Final Drainage Report

**Hill Subdivision
Filing No. 1**

Project No. 61174

PCD File No. **VR2313**

MVE PROJECT **61174**
 MVE DRAWING **EX-DRN**

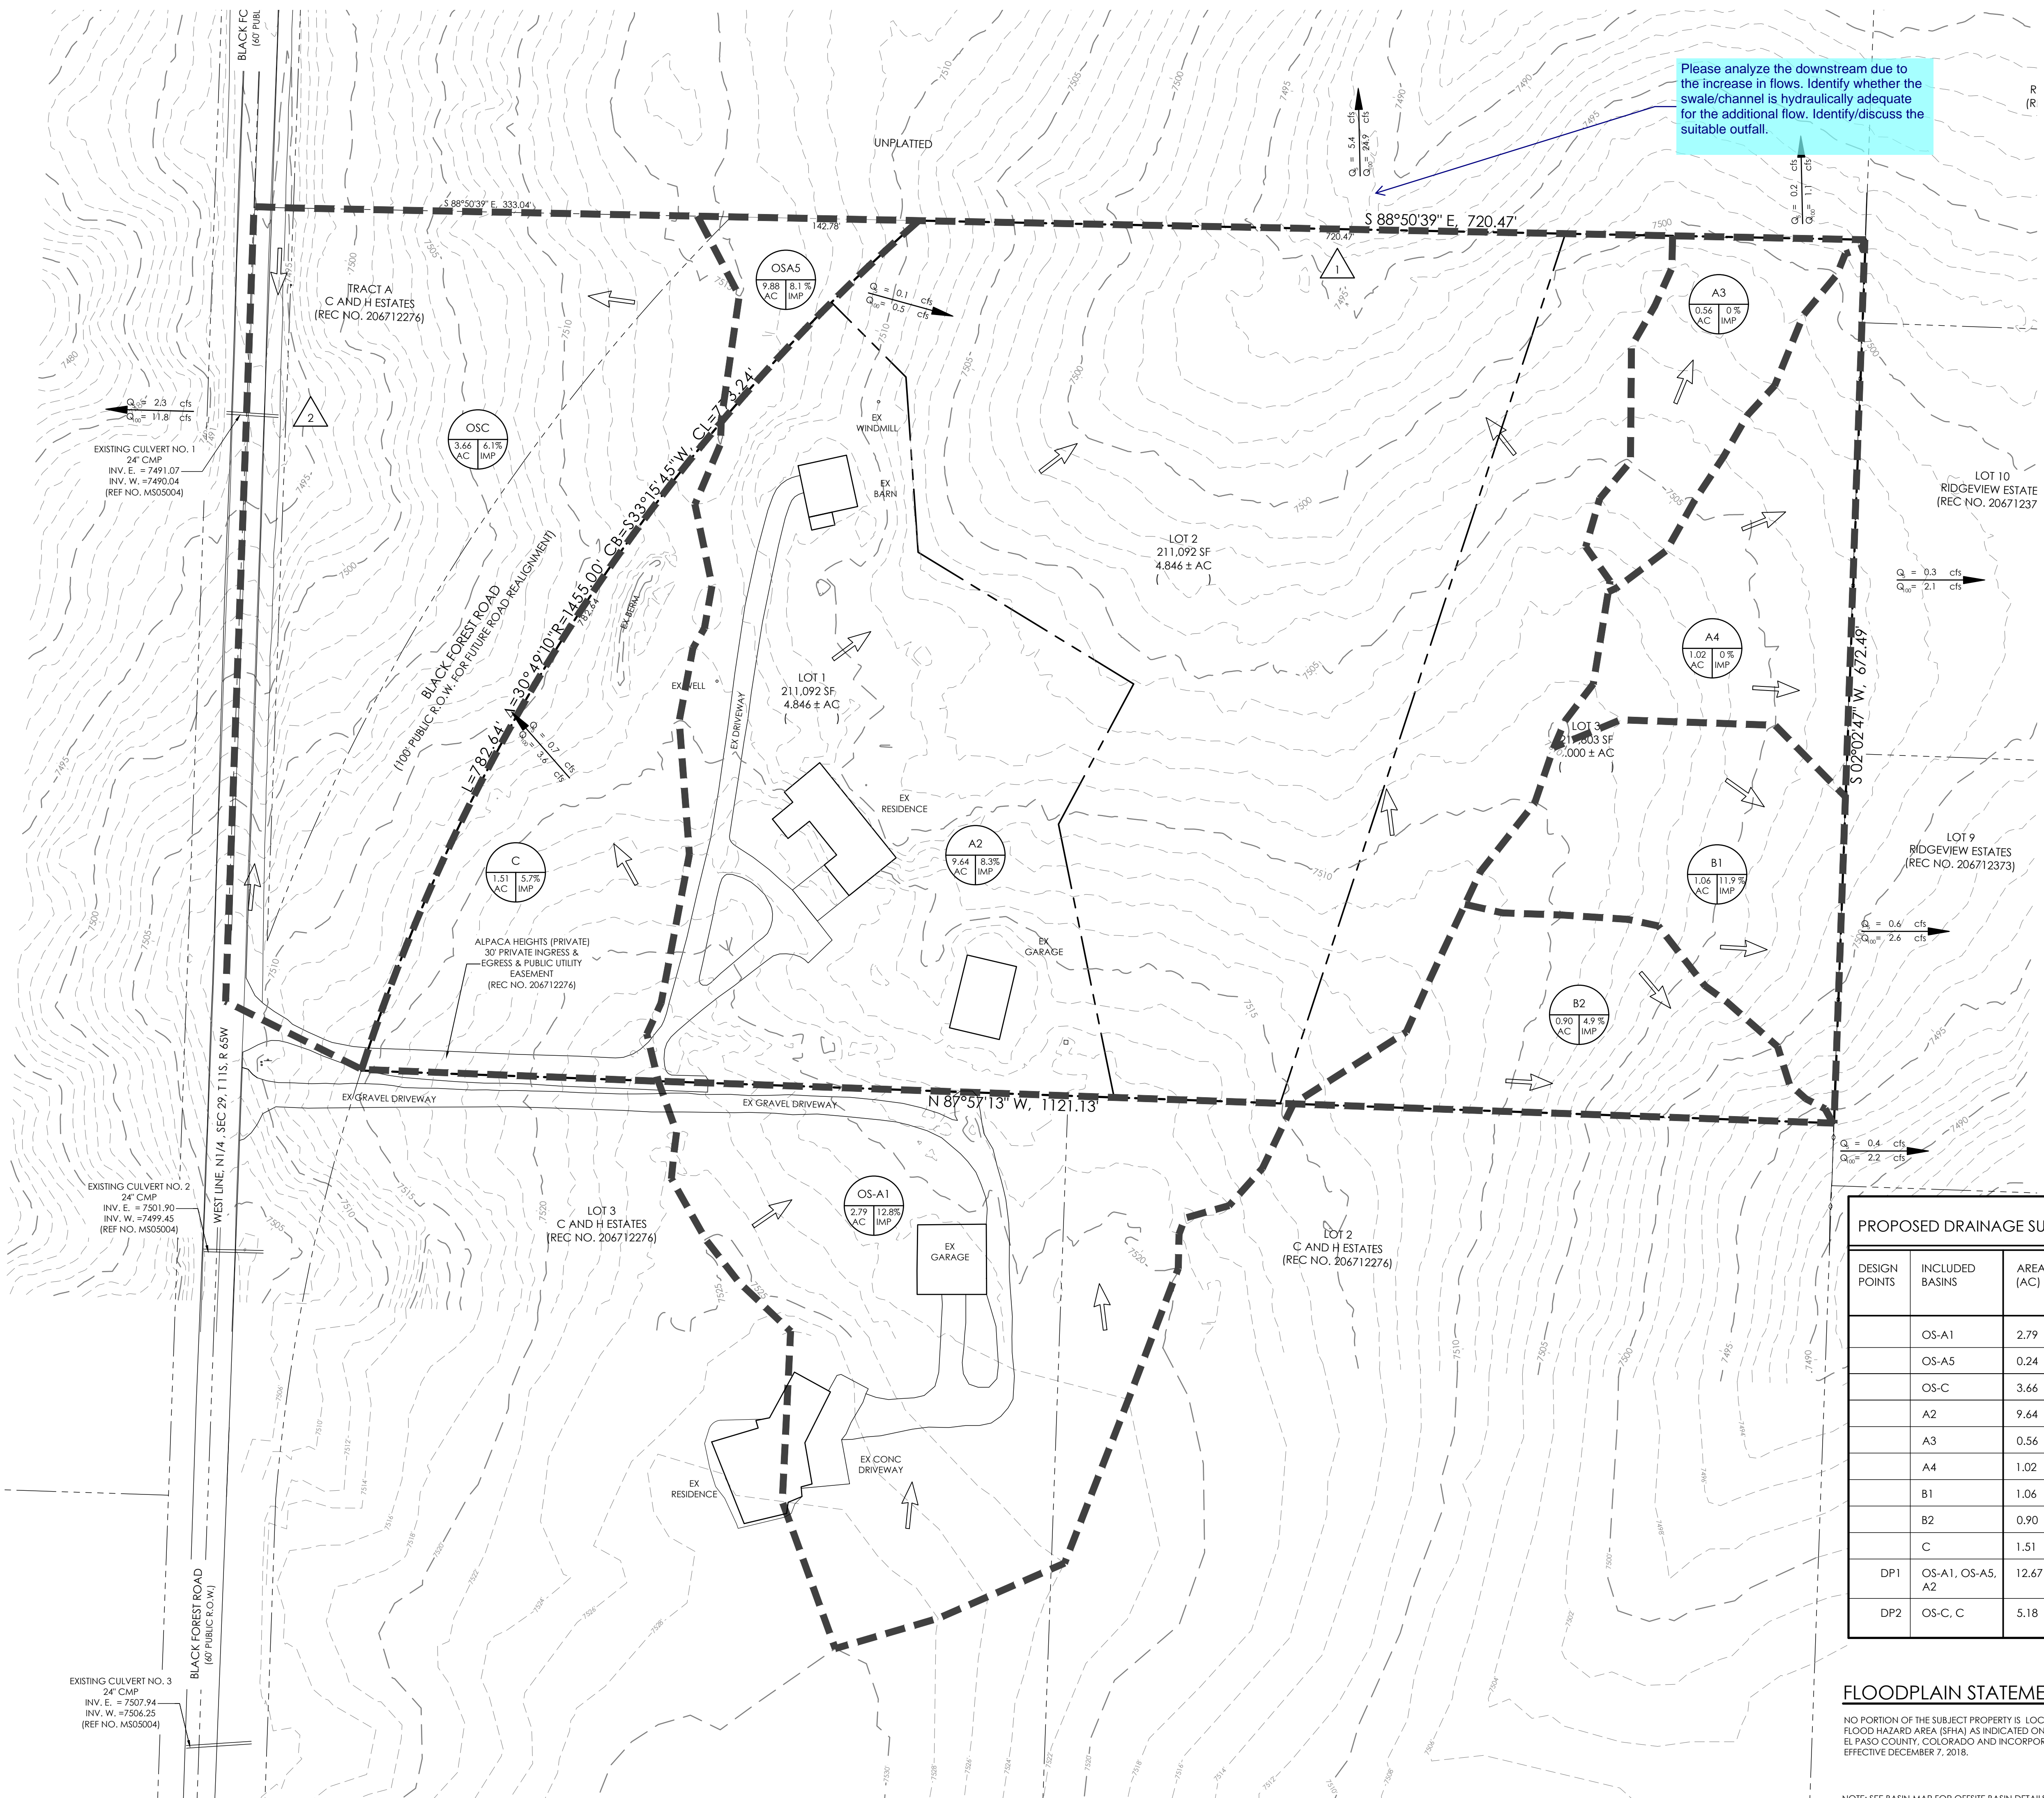
Please analyze the downstream due to the increase in flows. Identify whether the swale/channel is hydraulically adequate for the additional flow. Identify/discuss the suitable outfall.
